# Access Compliance Report

## Public Rights-of-Way

Intersection ID: 15996	Main Street: CHESTNUT_LAKE_DR	Cross Street: HICKORY_HOLLOW_LN	Location: NE
ADA ID: 6733DA4577C2	Ramp Type: Directional1	Initial Pass/Fail: Fail	Overall Compliance: No
Severity Score: 25			
Codes/Mitigation Info/Possible Solution		Field Measurements/Component Compliance

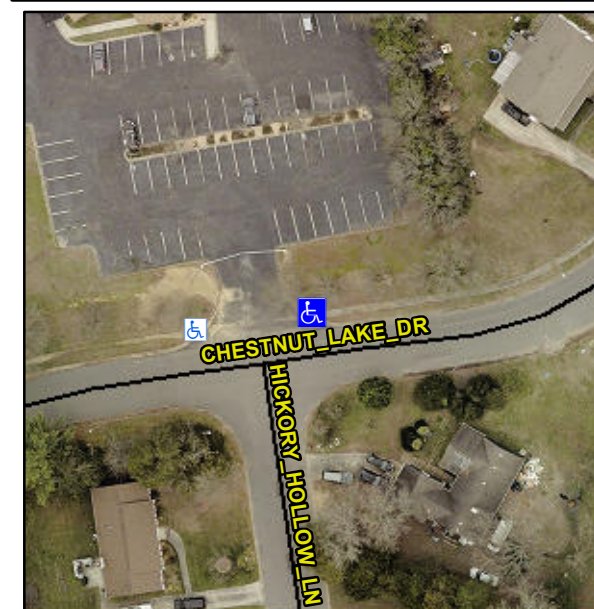
**Remove & Replace Entire Ramp.**

**R304.5.3**

Compliance	Description	Data	Compliance	Description	Data
N/A	Ramp Length (in)	68.0	N/A	Grade Break?	N/A
Yes	Ramp Width (in)	48.0	N/A	Grade Break Slope (%)	0.0
Yes	Ramp Slope (%)	7.9	N/A	Grade Break XSlope (%)	0.0
No	Ramp XSlope (%)	8.5			
N/A	Flare Type LT	N/A	N/A	Flare Type RT	N/A
N/A	Flare Slope LT (%)	N/A	N/A	Flare Slope RT (%)	0.0
N/A	Flare Traversable LT?	N/A	N/A	Flare Traversable RT?	N/A
N/A	Landing Length (in)	0.0	N/A	DWS Provided?	N/A
N/A	Landing Width (in)	0.0	N/A	DWS Contrast?	N/A
N/A	Landing Slope (%)	0.0	N/A	DWS Length (in)	N/A
N/A	Landing X Slope (%)	0.0	N/A	DWS Full Width?	N/A
N/A	Landing Curb? (Y/N)	N/A	N/A	DWS Offset LT (in)	N/A
N/A	Shared Landing?	N/A	N/A	DWS Offset RT (in)	N/A
N/A	Gutter Ponding?	0.0	N/A	Gutter Slope (%)	N/A
N/A	Gutter Lip Ht (in)	0.0	N/A	Gutter X Slope (%)	N/A
N/A	Painted X Walk1?	No		Road Slope (%)	0.1
	X Walk 1 Direction	To W		Road X Slope (%)	1.2
	X Walk 1 Width (in)	N/A		Clear Space?	N/A
